### Town of Kittery Planning Board Meeting September 12, 2019

#### ITEM 2 – 76 Dennett Road – Site Preliminary Plan Review

Action: Approve with or without conditions, continue consideration of or deny plan. Owners William J. Cullen and Sail Away, LLC and applicant William Wharff request consideration of a mixed-use residential development on 23.3+- acres of land at 76 Dennett Road (Tax Map 6 Lots 15B & 16A and Tax Map 13, Lot 4) in the Mixed Use - Neighborhood (MU-N) Zone. Agent is Shawn Tobey, P.E. Hoyle, Tanner & Associates, Inc.

# Conceptual Elevations - Building 2

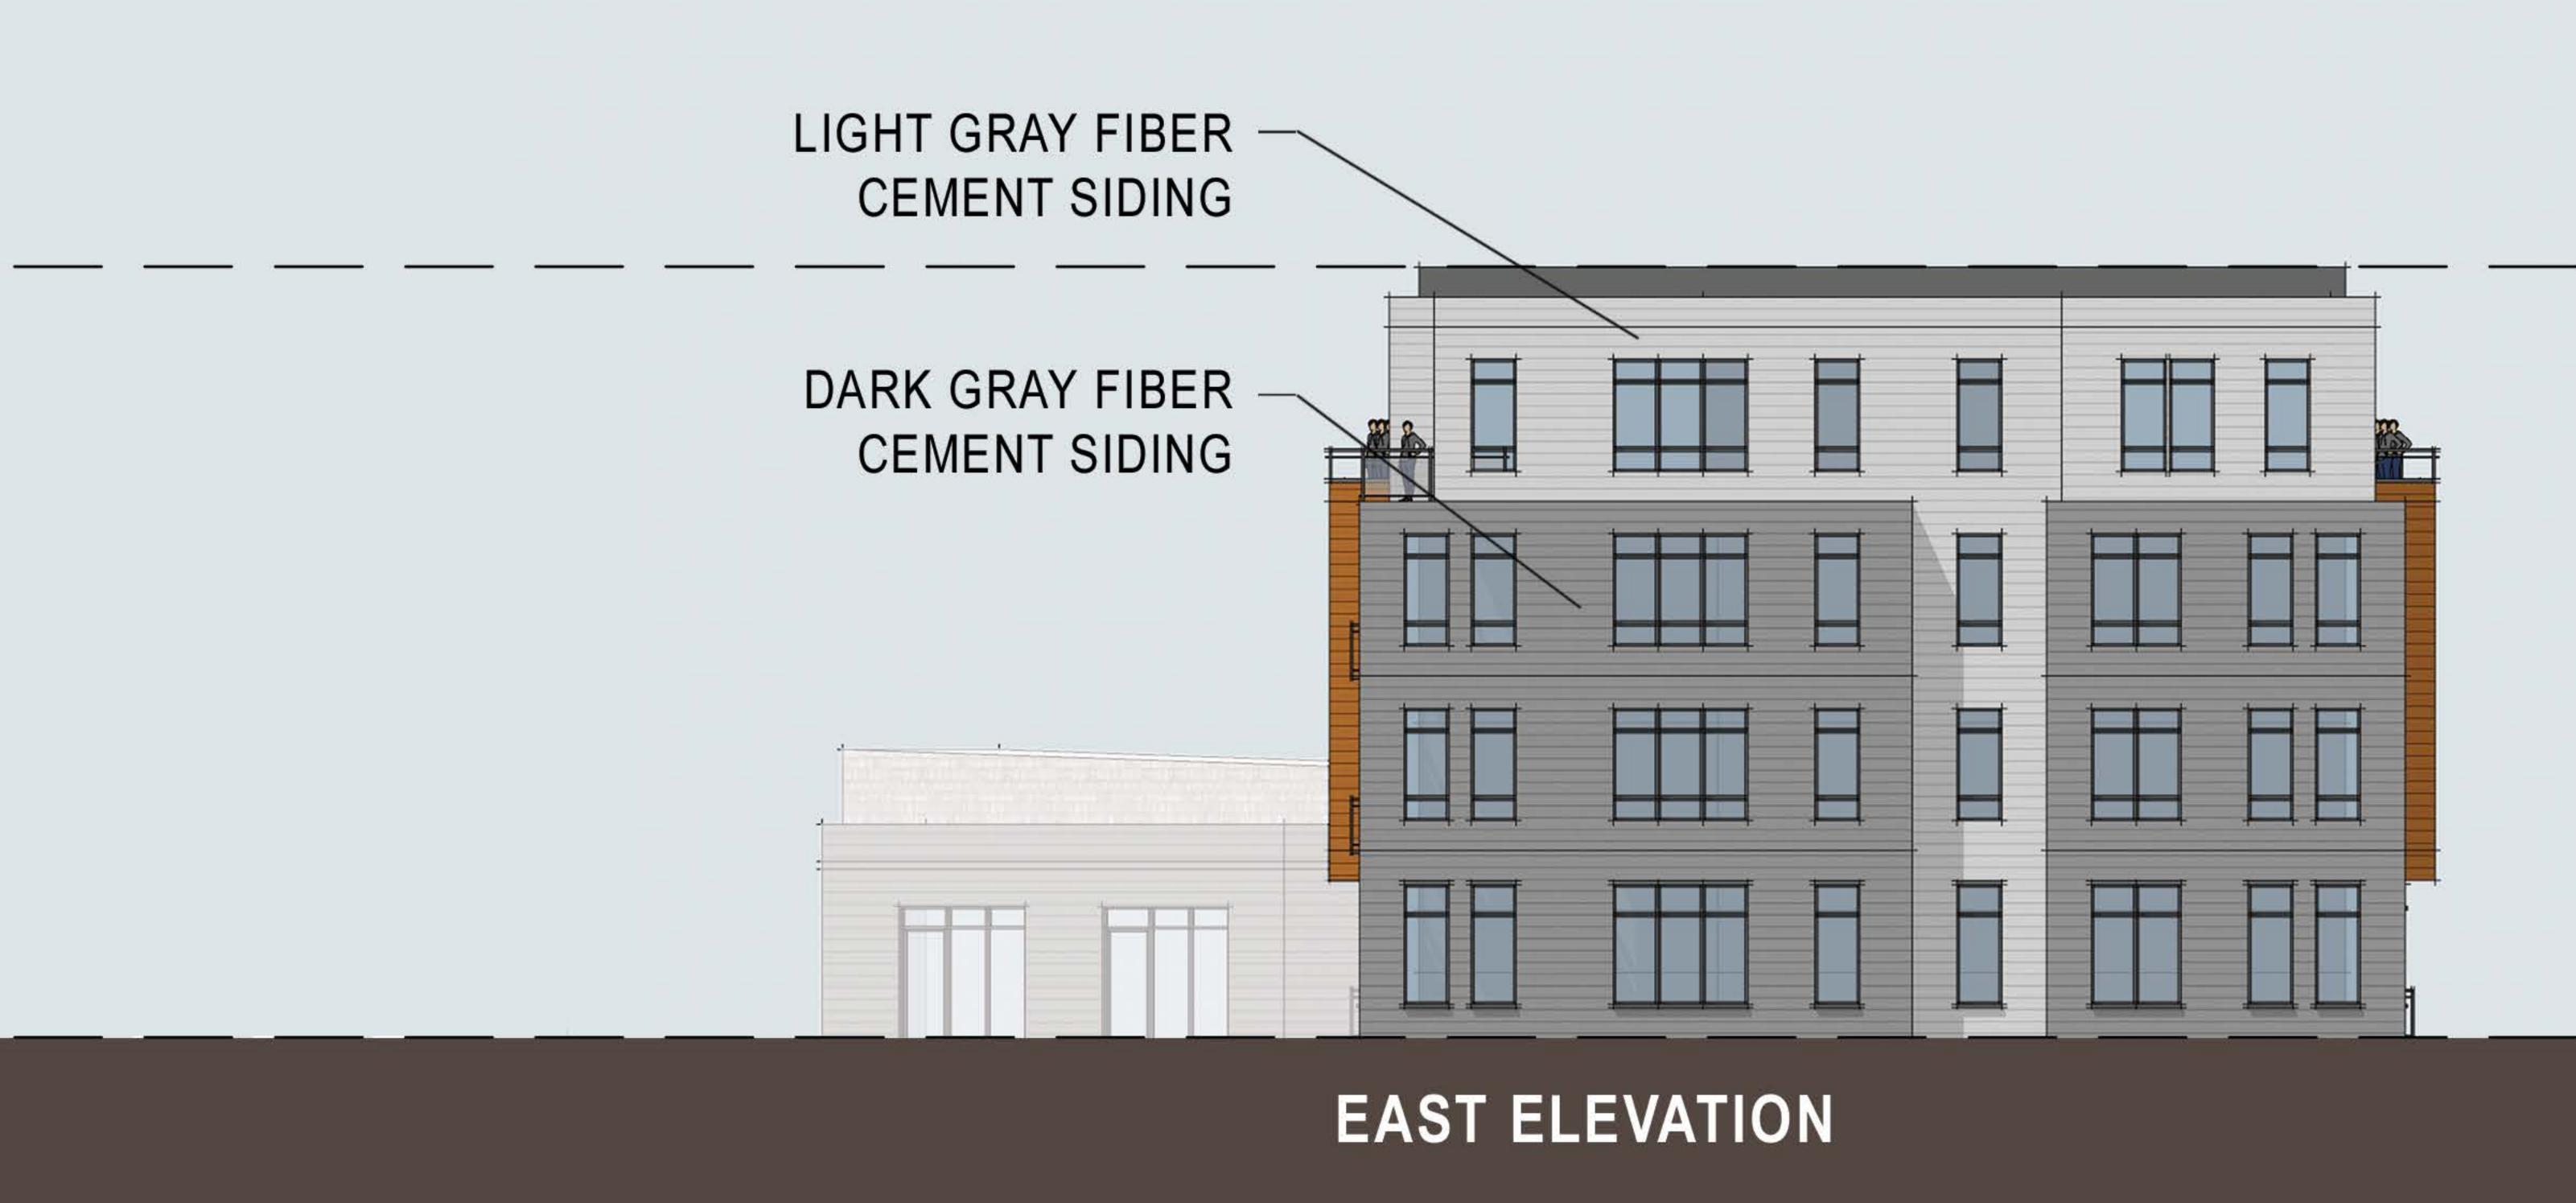
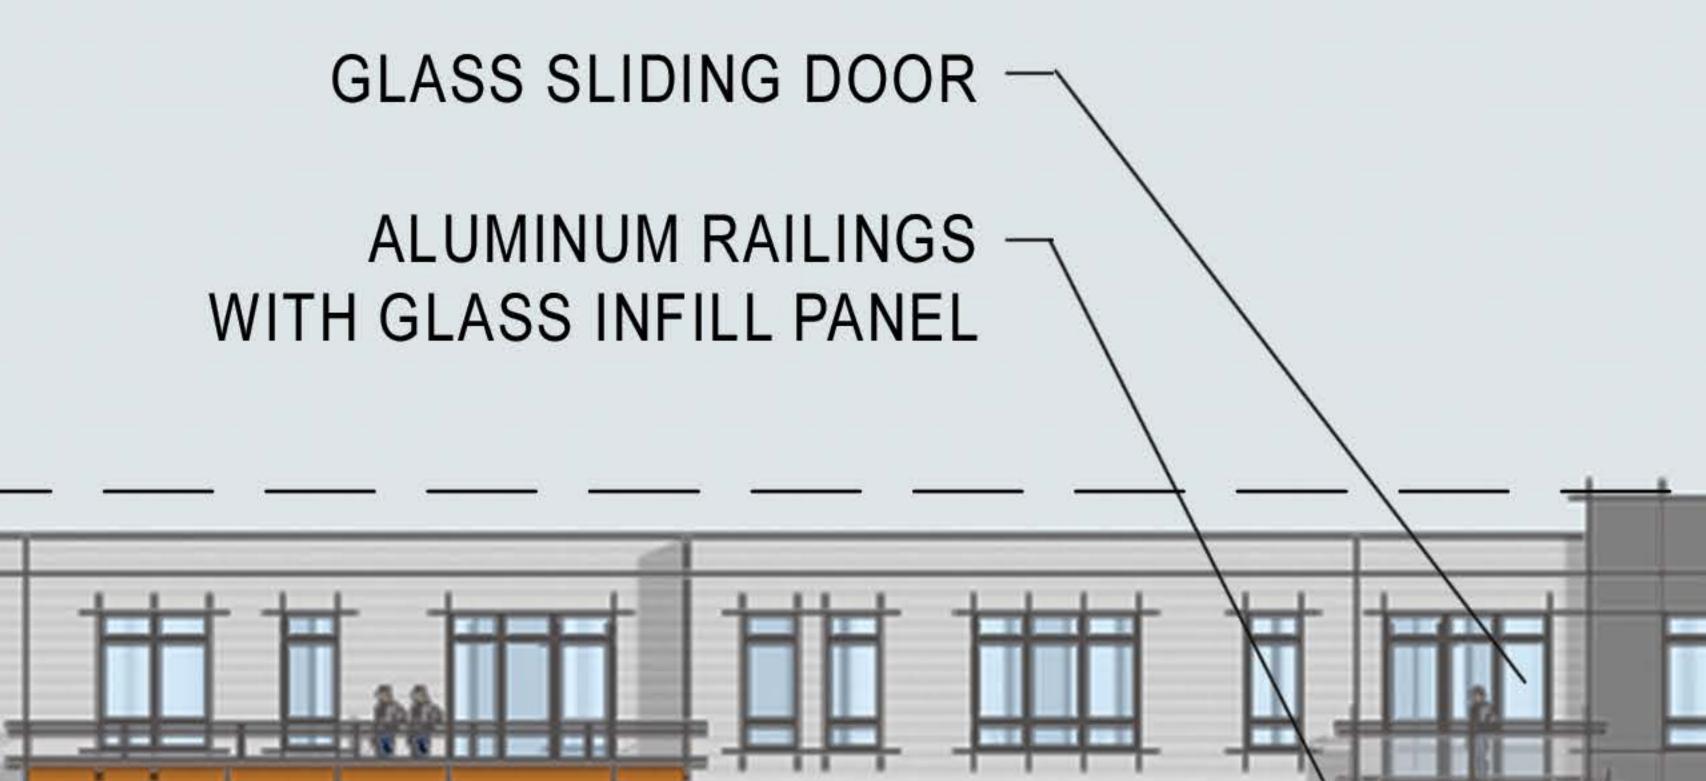
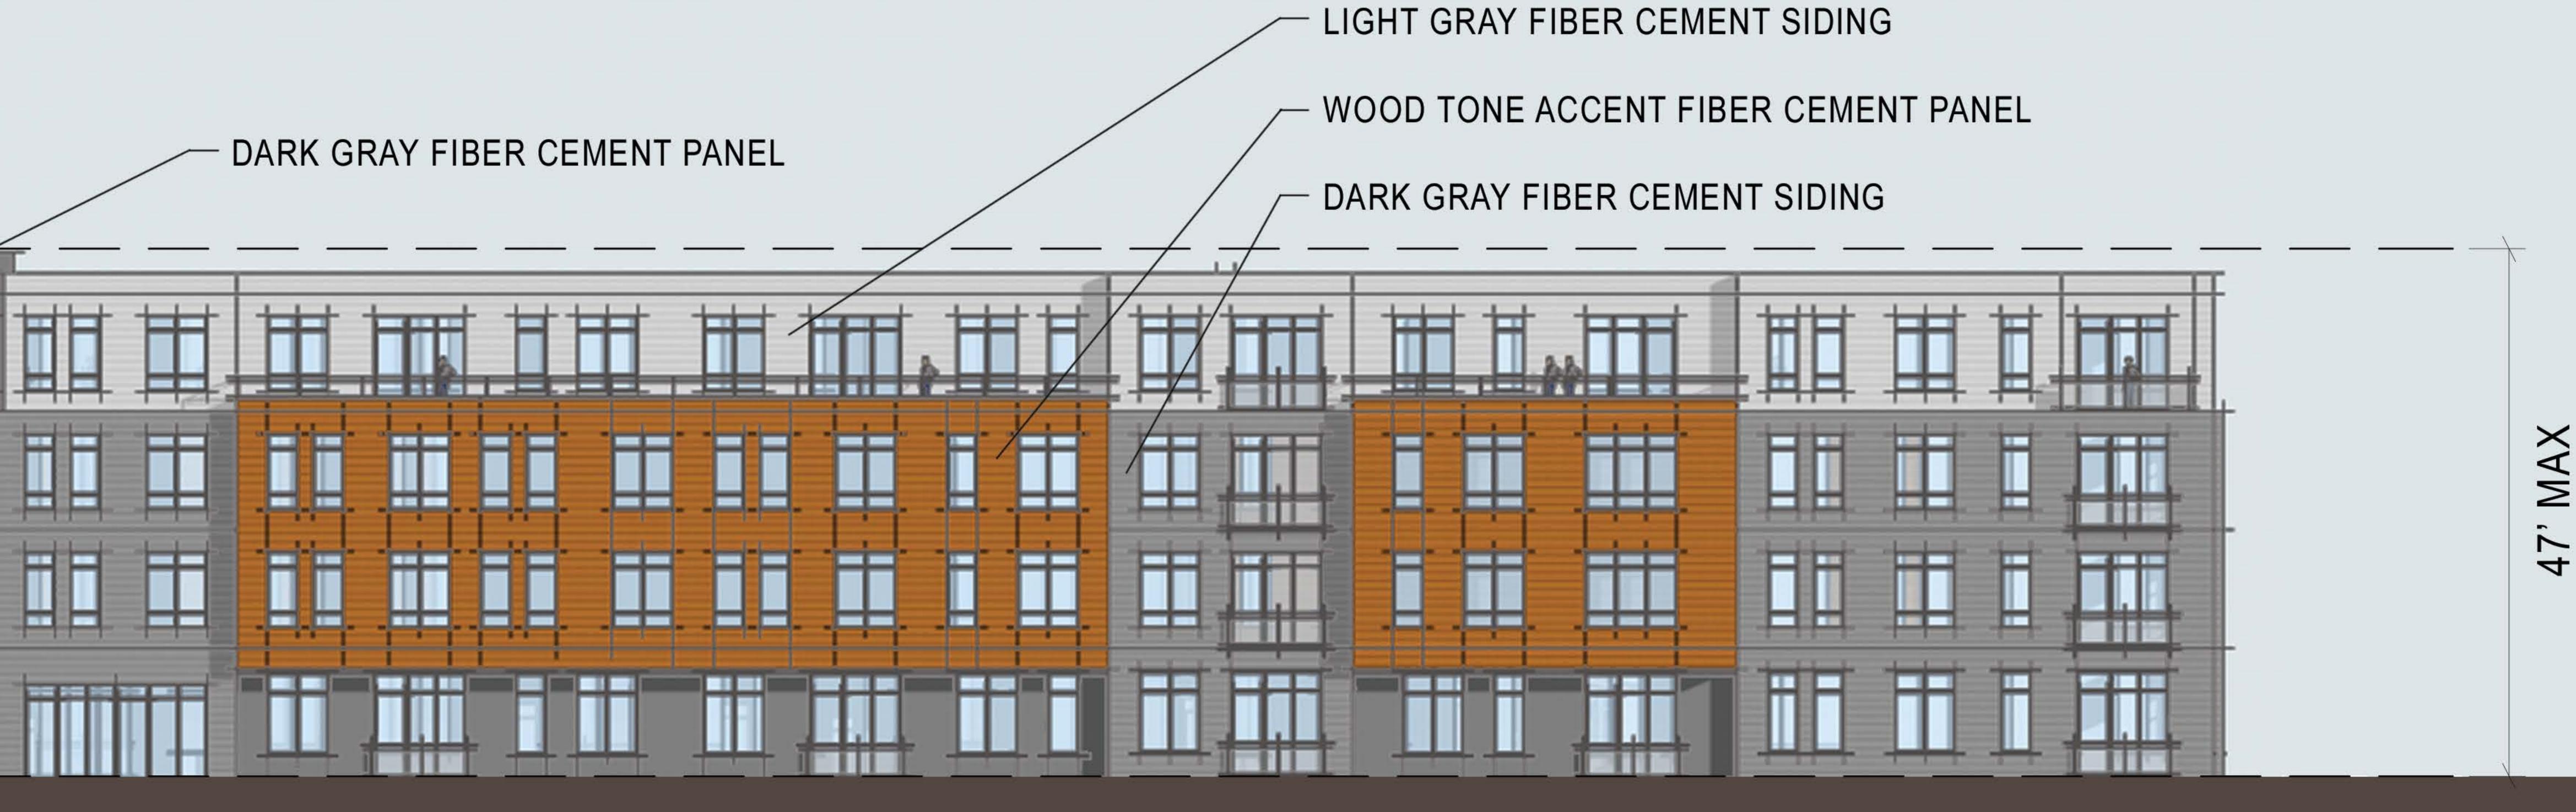
- 12. Jessa Kellogg, Interim Code Enforcement Officer, has also provided a memorandum regarding her initial building code review conceptual floor plans that have been submitted. The Response to Review Comments letter from Hoyle, Tanner & Associates were included in the August 8<sup>th</sup> meeting packets. Update: All studio units have been revised to be a minimum of 650 sf. Habitable space needs to be clearly indicated in the floor plans. A legend has been added to the architectural plans and the building elevations revised to show building heights and materials.

- All studio units were revised to be a minimum of 650 SF.
- A legend was added.
- Dimensions depicting building heights were added to the elevations
- Building material callouts were added to the elevations.
